Access Compliance Report

Public Rights-of-Way

(Pedestrian Signals)

Intersection ID: N/A	Main Street:	Cross Street: N/A	Location: N/A
ADA ID: 37A90B58FAD0	Signal Type: One Push Button-APS	Overall Compliance: No	Severity Score: BTN 1: N/A BTN 2: N/A No BTN: N/A
Codes/Mitigation Info/Possible Solution		Field Measurements/Component Compliance

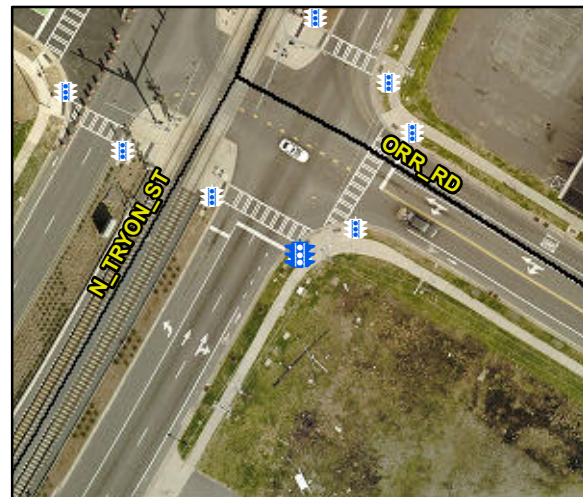
Surveyor Notes: TEXT HT 5/16

PROW/ADA: R410.6, TMUTCD 4e.08, R404.2, R406.2, R209.1, MUTCD 4e.10

Possible Solutions: Replace Signal Push Button With APS Button on New Post. Remove & Replace Sign.
